Subject: Quanex Corporation, South Lyons, MI MID 082 767 591

TO: Lynne King, Northville District Office, WMD  
FROM: Liz Browne, HW Permits, WMD *Liz*  
SUBJECT: Quanex Corp., Michigan Seamless Tube Division  
South Lyons, MID 082 767 591

Quanex Corporation  
MID 082 767 591  
O&M Inspection-1993

FIGURE 1  
SHALLOW WELLS  
GROUND WATER CONTOUR MAP  
(MEASUREMENTS MADE 12-10-93)  
QUANEX CORPORATION  
MICHIGAN SEAMLESS TUBE DIVISION  
SOUTH LYON, MICHIGAN  
FEBRUARY, 1994

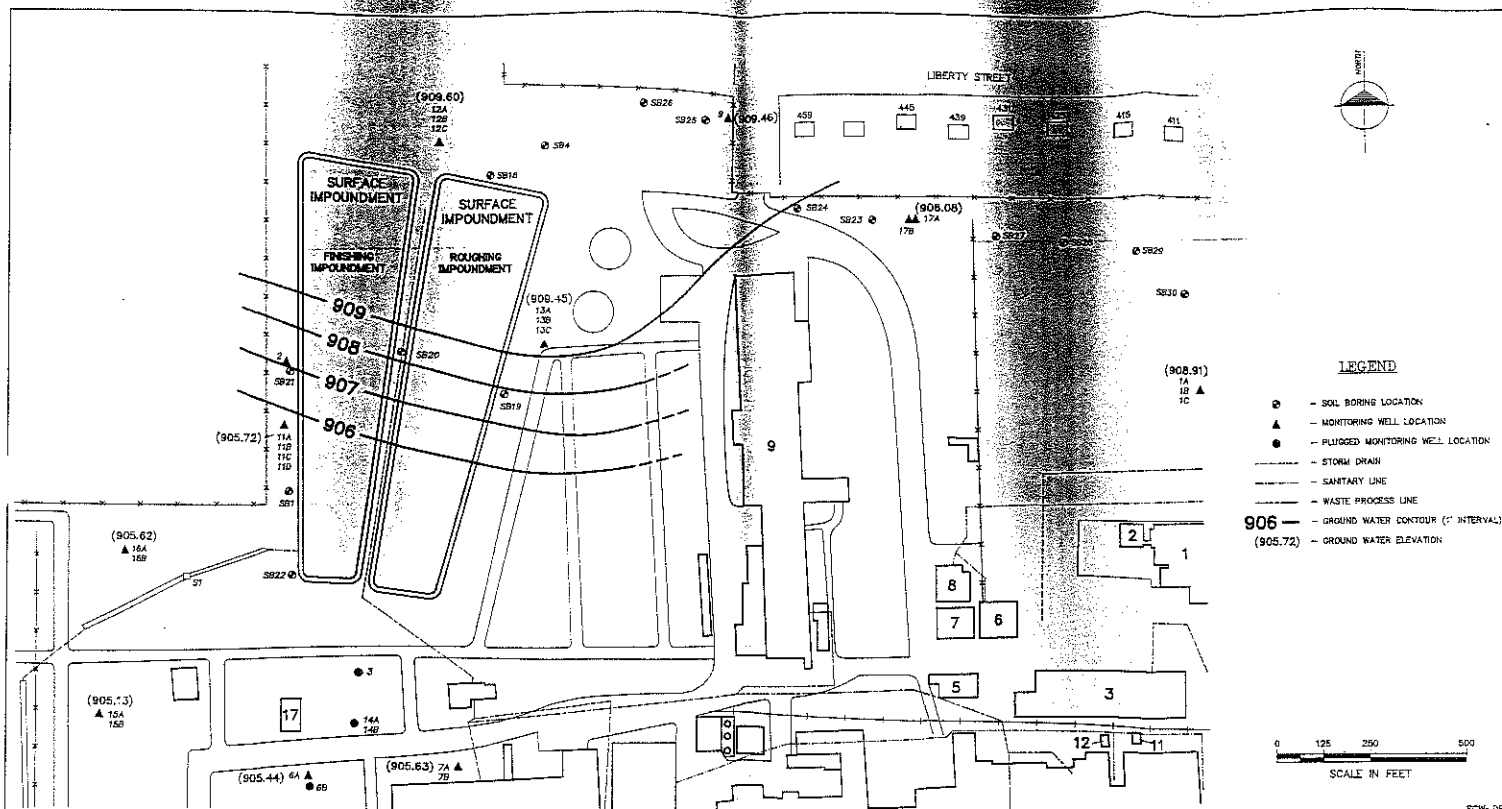
These groundwater elevations are similar to those measured on December 10, 1993, by WW Engineering & Science (WWES). Since the static water level measurements by the consultant are acceptable, groundwater contour maps presented in the Annual Groundwater Report for 1993 are included to show the site groundwater flow direction.

The upper and lower portion of the glacial drift aquifer have different groundwater flow directions. The upper part of this unconfined aquifer flows south/southwest, while the lower portion flows westerly. Both directions are consistent with historic data.

# Piper Diagram

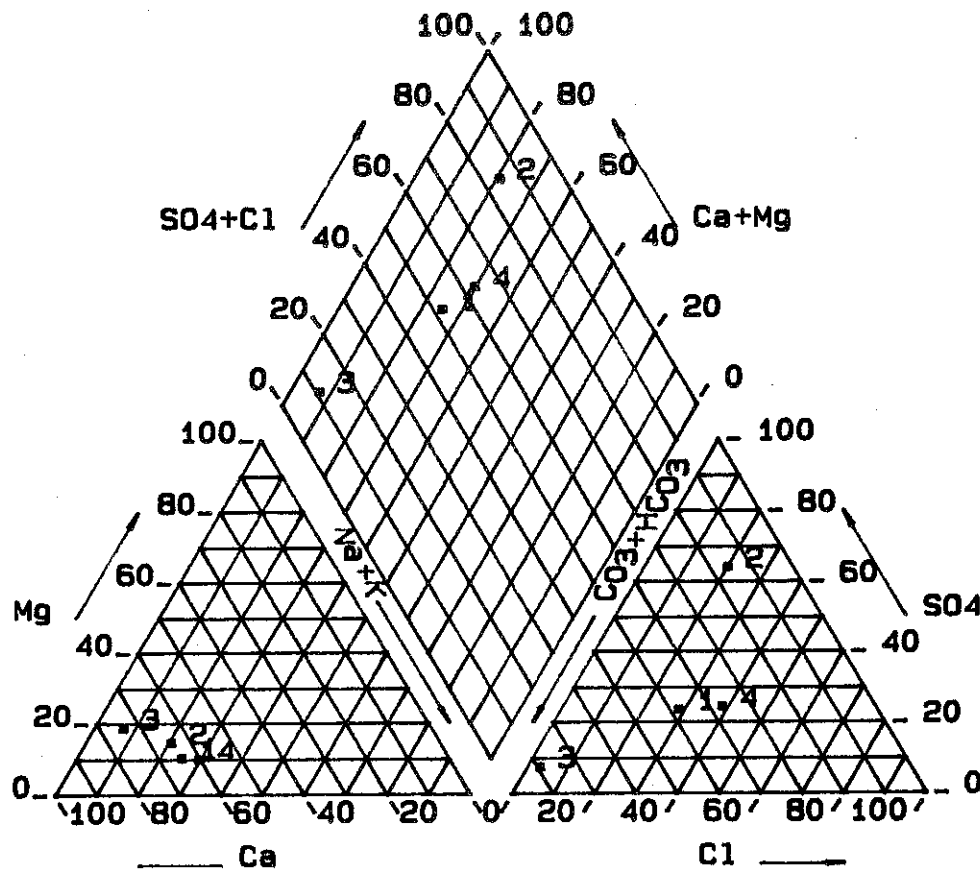
Analysis of the major ions was done using Stiff and Piper diagrams, along with Pie charts and bar graphs. These analyses show that the four upgradient wells sampled are similar in general chemistry. The two downgradient wells that are adjacent to the surface impoundments do show an impact. Well MW-11A has a relatively higher concentration of sulfate in the MDNR sample, while MW-13A has a higher concentration of bicarbonate. This can be seen for example on Figure 2, the Piper diagram where wells labeled "2" (MW-11A) and "3" (MW-13A) plot in areas away from the other wells.

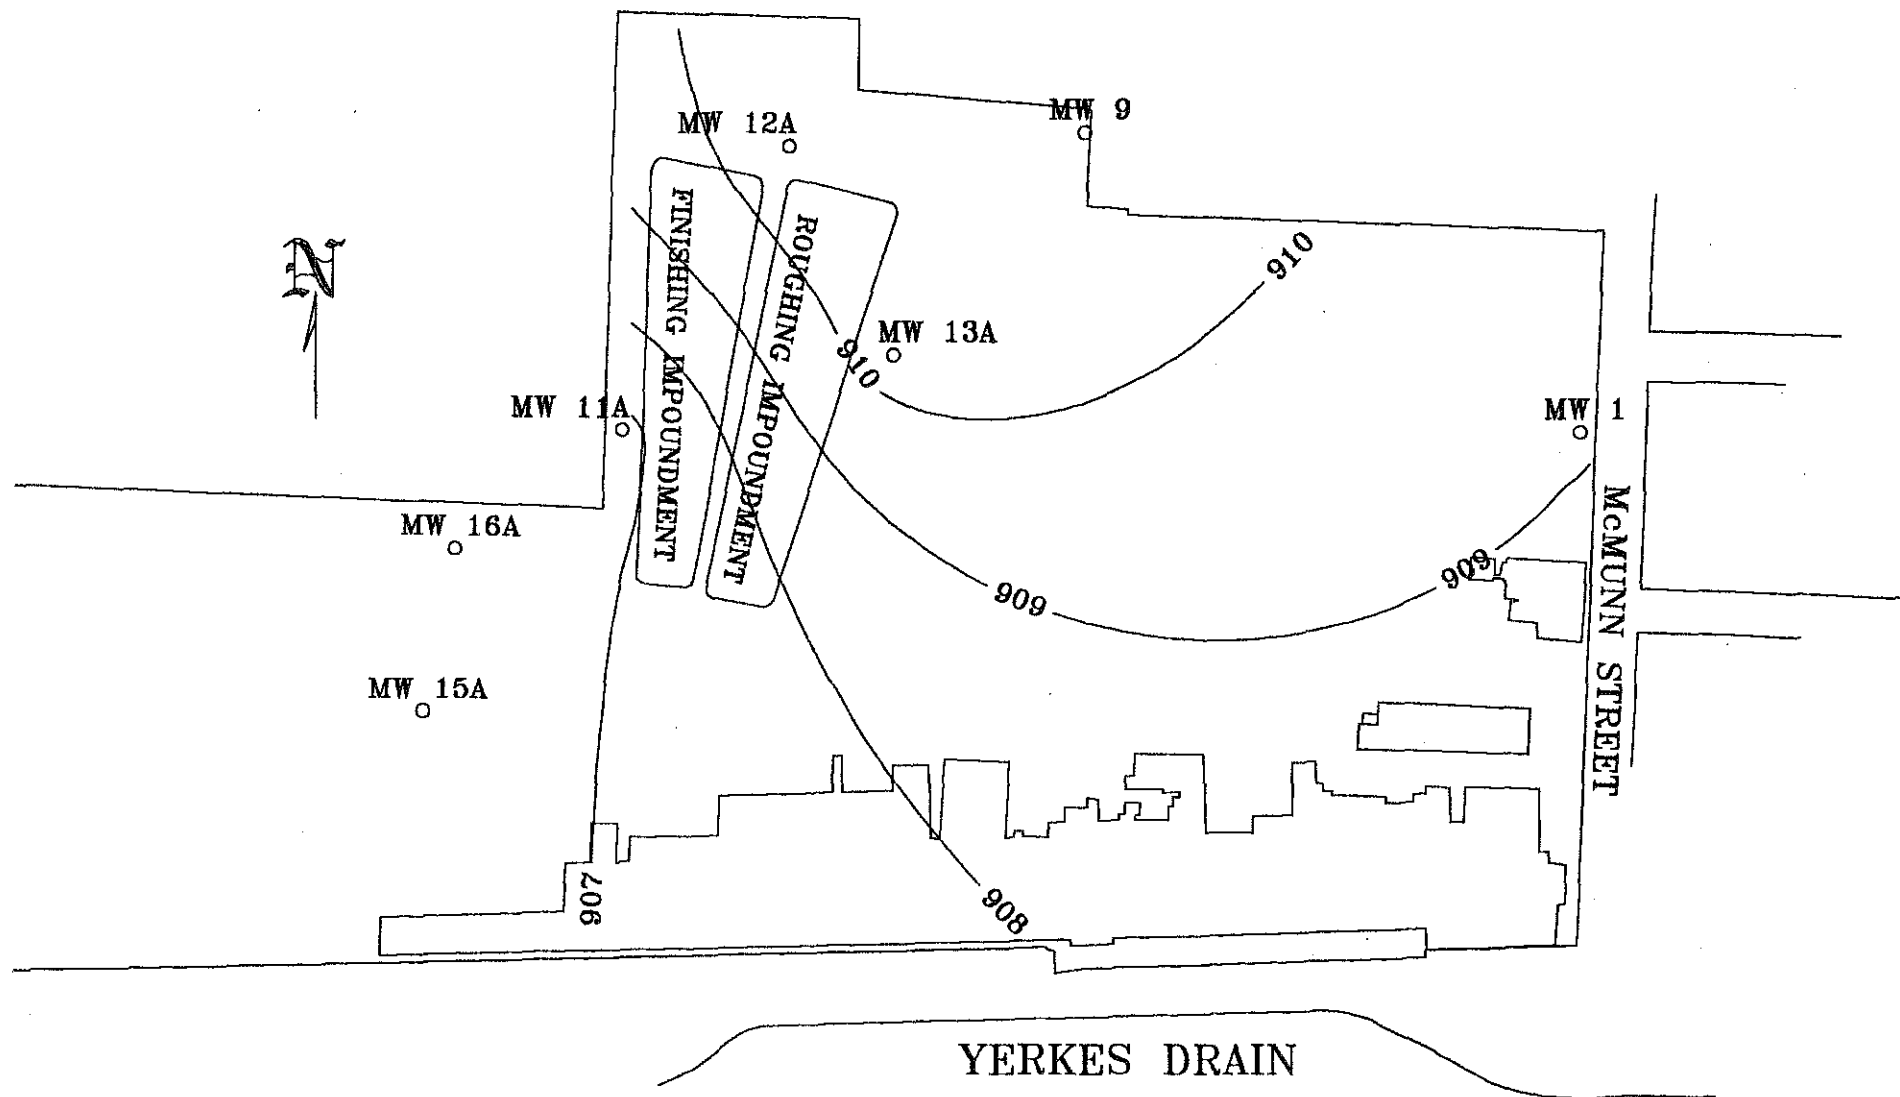
Vertical gradients are well documented at this site because of the excellent system of well clusters found here. Vertical gradients are important in relation to the question of whether the low levels of arsenic detected in some wells comes from the impoundments or is naturally occurring deeper in the aquifer. Although there are variations, most wells clusters show a downward gradient from the shallowest well ("A") to the next deeper one ("B") for wells 11, 12, 13, 15, 16. For well clusters with a deep well ("C"), there is an

upward gradient from the deepest (C) to the mid-level (B) well (MW 12, 13). For well cluster 11, there are four wells at various depths. There is a downward gradient from shallow (A) to mid (B and C), and usually an upward gradient from the deepest (D) to the "C" well. There is a question however regarding the top of casing elevation. For example, for well 11D, the Groundwater Assessment Report (4/86) listed the TOC elevation as 921.07, the 1988 Annual GW report has 920.77, and the 1990 Annual GW report lists 921.77. The overall difference of 1.0 feet can make a large difference in the interpretation of vertical gradients.

The vertical gradient question is important regarding the source of the arsenic and 1,1 dichloroethane found in wells 11A and 11B, and the arsenic found occasionally in wells 11D, 12B, 13A, 13B, and 14A. It is possible that the arsenic may have come from the impoundments because arsenic is detected in well 11A on some occasions, and in 11B consistently. There is a consistent downward gradient from 11A to 11B. Arsenic was also detected consistently in well 14A until its removal. Wells 11A, 13A, and 14A are shallow.
